U.S. NUCLEAR REGULATORY COMMISSION  
REGION I

Report No. 50-412/87-68

Facility Name: Beaver Valley Unit No. 2

Inspection Summary: Inspection on November 18-21, 1987 (Inspection Report No. 50-412/87-68)

### 4kV Bus Breaker Control Circuit\*

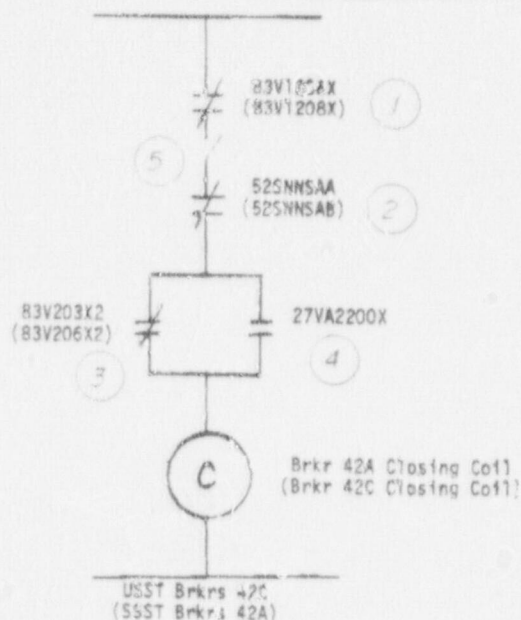
3. There is an unintentional overlap in the 52S closing coil circuit contacts (see Attachment B and C) on the pallet switches of the USST and SSST breakers. These contacts are of an "early D" design to provide fast transfer from the USST to the SSST and vice versa. The intent of the design is to ensure that one set of breakers cannot reclose if the opposite set is closed and to keep to a minimum the time that the unit and system 4kV Breakers are both open with an unpowered bus. However, the design did not function entirely as intended because of the above contact overlap combined with the fast transfer feature in both directions (i.e., fast transfer from the unit generator to the offsite grid or a fast transfer from the offsite grid to the unit generator) and the use of non-seal in type of relays as noted in items 1. and 2. above. When the momentary thrust bearing failure trip signal cleared, the relays reset. This allowed the USST breakers to reclose, although the SSST breakers were closed.

The first design deficiency is in the circuitry which initiates a generator trip and automatic fast transfer of the 4kV buses from the USSTs to the SSSTs on turbine trip which does not include a seal-in feature. (Refer to Attachment A for breaker, transformer and bus designations). The second deficiency is that feature of the design which provides for automatic fast transfer of the 4kV buses in the reverse direction, i.e., from the SSSTs back to the USSTs. The third design deficiency is the overlap closure of the auxiliary "early b" contacts of the 4kV breakers. (See Attachment C for a discussion of electrical breaker "early b" contacts.) When the momentary turbine thrust bearing failure signal reset, this reset the trip signal to the USST breakers (42C, 142C, 242D, 324D) which connect the USSTs to the 4kV buses. But the USST breakers had already started to open and by means of their "early b" auxiliary contact had completed the close circuit for the SSST breakers (42A, 142A, 242B, 342B) which connect the SSSTs to the 4kV buses. The SSST breakers, therefore, had begun to close but their "early b" auxiliary contact which is closed and is in the close circuit of the USST side breakers did not open before the reset of the trip signal to the USST breakers. Therefore, for a momentary interval or overlap, both sets of 4kV bus breakers simultaneously had a close signal.

The licensee determined by tests performed (see Section 3.3) on the 4kV bus breakers that an "early b" contacts closed overlap condition existed in the automatic close circuits of these breakers. This condition would permit simultaneous closure of both supply breakers on each 4kV bus if the trip signal to the USST side breakers were removed before the SSST side breakers had fully closed.

The reverse automatic bus transfer from the SSSTs back to the USSTs was defeated by inserting a knife switch in the auto closure circuit of each 4kV bus breaker. The switches in the close circuit of the USST side breakers will be kept open, which prevents automatic reclosure of these breakers thus defeating the reverse auto transfer of the buses back to the USSTs. The knife switches in the close circuit of the SSST side breakers will be kept closed thus retaining the auto transfer from the USSTs to the SSSTs. The knife switches are physically installed in their respective breaker cubicles and will be maintained in the proper position by administrative controls. Indicator lights in the control room show that each of the eight knife switches are in the correct position. The licensee indicated

5. Knife Switch: added in the circuit as a modification to allow fast transfer only in one direction (i.e., from USST to SSST). The knife switches on the USST side breakers will be kept open and those on the SSST side will be closed to permit such a transfer.
